**Economic and Social Council**Distr.: General
20 February 2020

World Forum for Harmonization of Vehicle Regulations**Working Party on Passive Safety****Sixty-seventh session**

UN Regulation No. 94 (Frontal collision)**Proposal for to the 04 series of amendments to UN
Regulation No. 94 (Frontal collision)****Submitted by the experts from Japan and the European Commission on
behalf of the Task Force ***

Model B

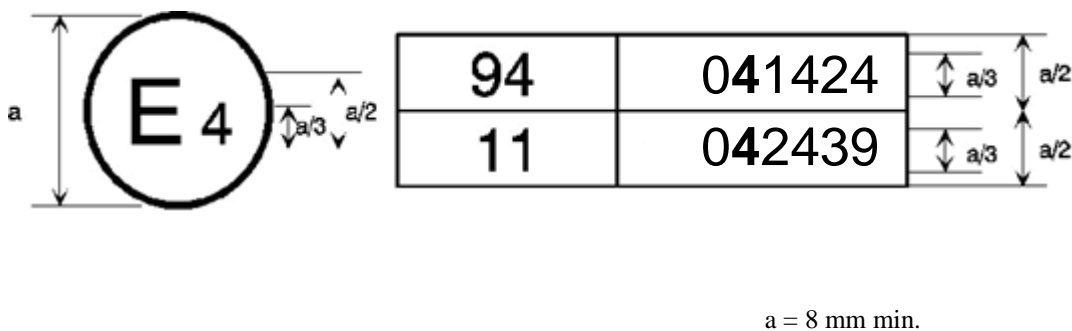
Annex 2, amend to read:

The first two digits of the approval numbers indicate that, at the dates when the respective approvals were granted, UN Regulation No. 94 incorporated the 04 series of amendments and UN Regulation No. 11 incorporated the 04 series of amendments."

Figure 3
Jointed Test Finger

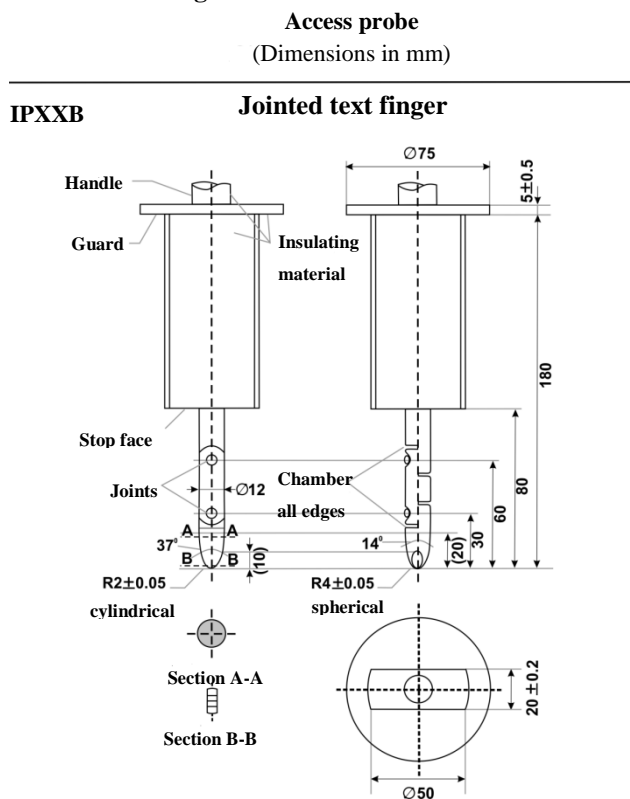
The jointed test finger described in **Figure 31** of ~~Appendix 1~~ shall be inserted into any gaps or openings of the physical protection with a test force of $10 \text{ N} \pm 10$ per cent for electrical safety assessment. If partial or full penetration into the physical protection by the jointed test finger occurs, the jointed test finger shall be placed in every position as specified below.

The requirements of paragraph 5.2.8.1.3. of this Regulation ~~are shall be considered to be met~~ if the jointed test finger described in Figure 31 of Appendix 1, is unable to contact high voltage live parts.

Figure 4
Example of test method using DC power supply

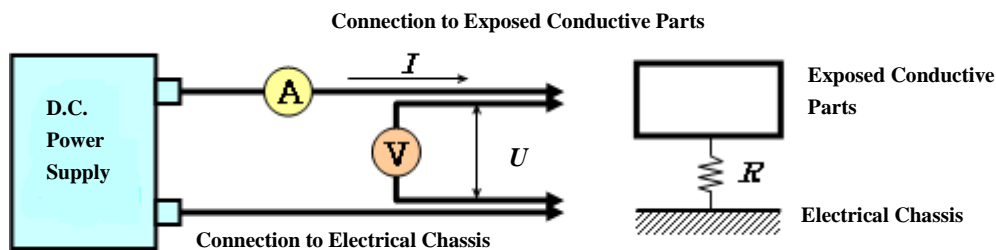
4.1. Test method for measuring electric resistance:

Example of the test method using DC power supply, voltmeter and ammeter is shown below.

Figure 5
Measurement of U_1'

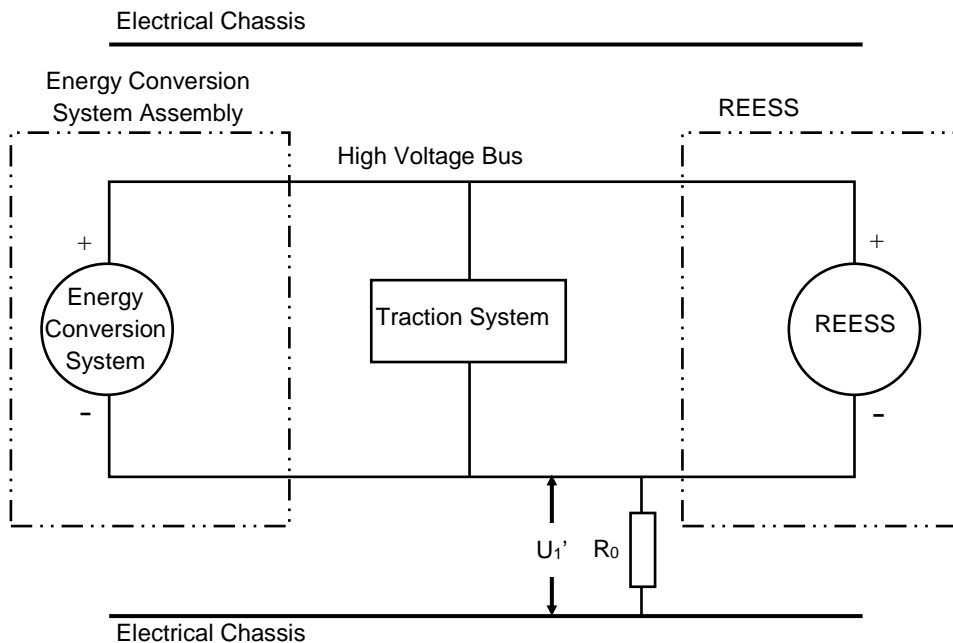
If U_1 is greater than or equal to U_2 , a standard known resistance (R_0) is inserted between the negative side of the high voltage bus and the electrical chassis. With R_0 installed, the voltage (U_1') between the negative side of the high voltage bus and the electrical chassis is measured (see Figure 5).

Figure 6
Measurement of U_2'

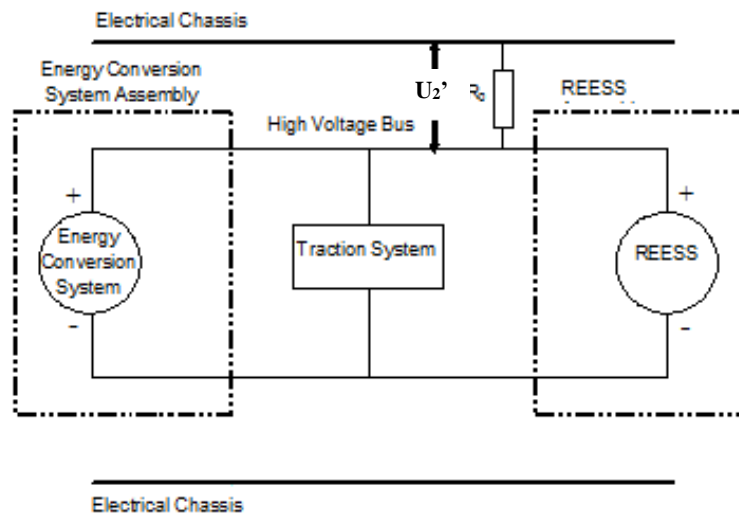
If U_2 is greater than U_1 , insert a standard known resistance (R_0) between the positive side of the high voltage bus and the electrical chassis. With R_0 installed, measure the voltage (U_2') between the positive side of the high voltage bus and the electrical chassis (see Figure 6 below). The electrical isolation (R_i) is calculated according to the following formula:
